CITY OF ALBUQUERQUE

**RE: Loud House @ Journal Center
7777 Jefferson St NE
Grading and Drainage Plan
Engineer's Stamp Date: 3/10/2023
Hydrology File: D17D002B**

Based upon the information provided in your submittal received 9/29/2023, the Grading & Drainage Plan is **not** approved for Building Permit. The following comments need to be addressed for approval of the above referenced project:

G-102-R

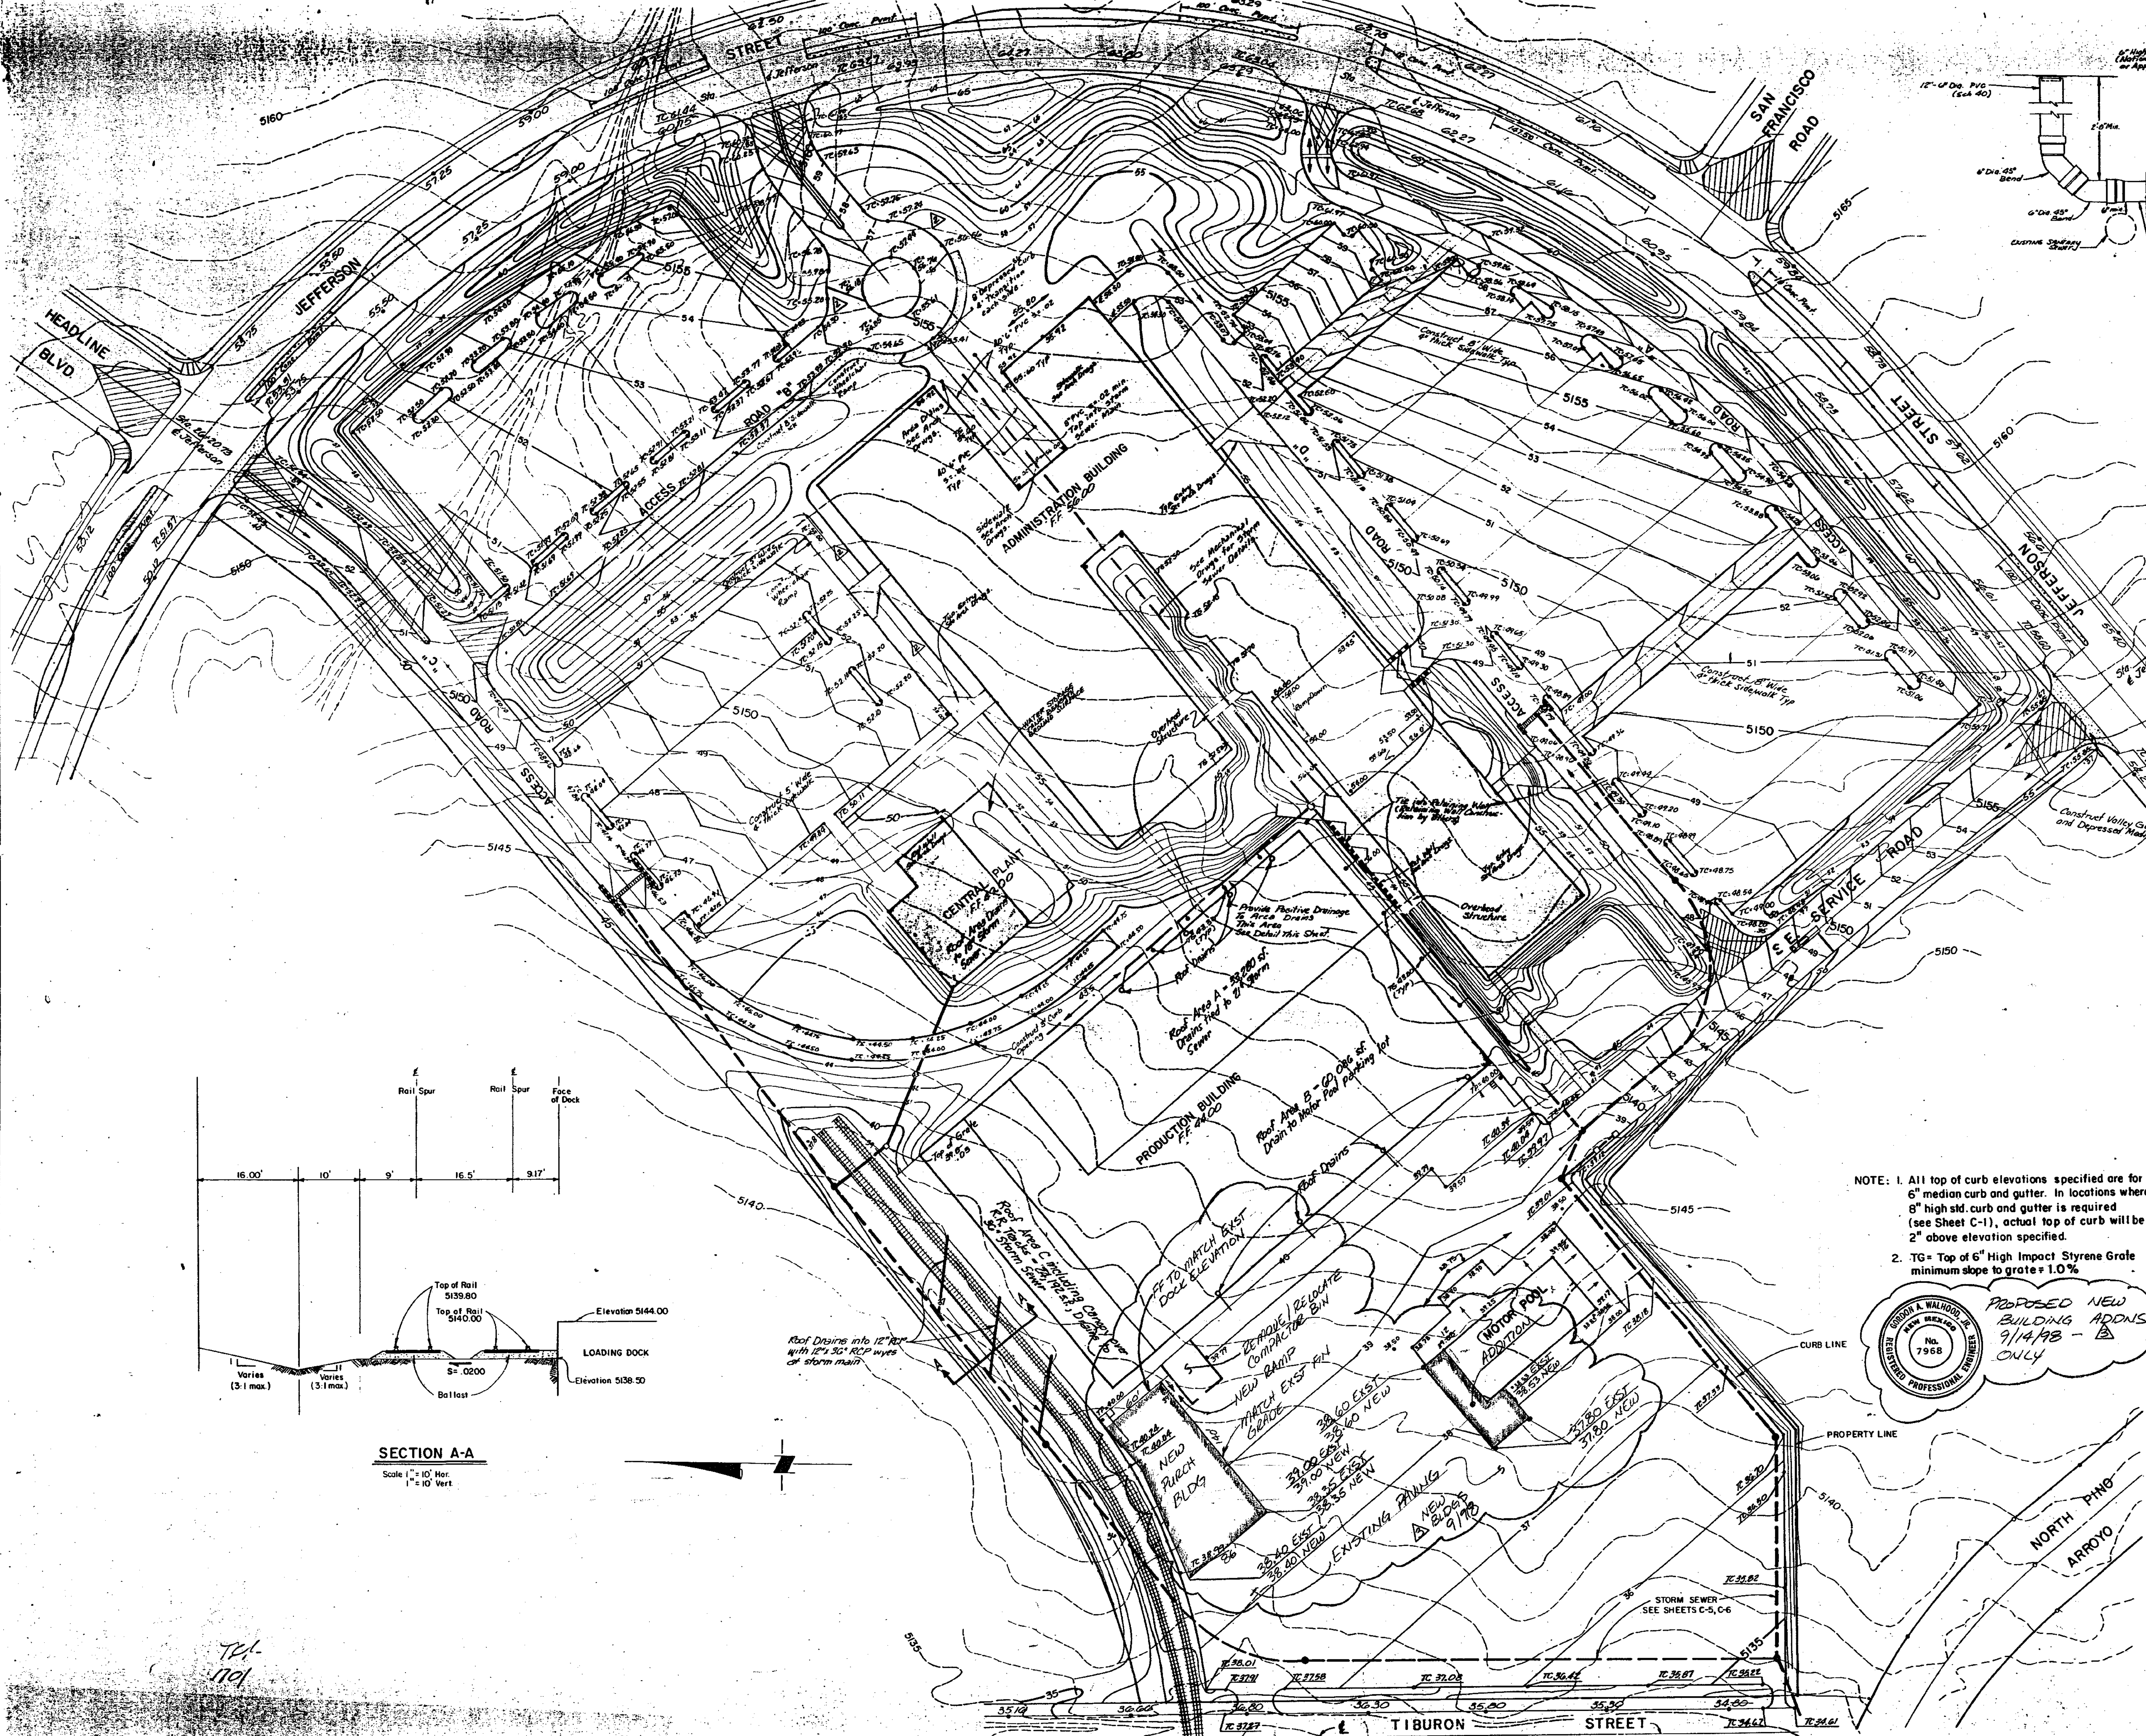
1. Please provide legend and bench mark on the plan.
2. Add topographic survey contour lines on the plan.
3. Calculate stormwater quality volume (SWQV) per the City of Albuquerque DPM article 6-12. Manage the SWQV by management on-site, or payment-in-lieu, or private off-site mitigation.
4. Add street names on sheet G-102.
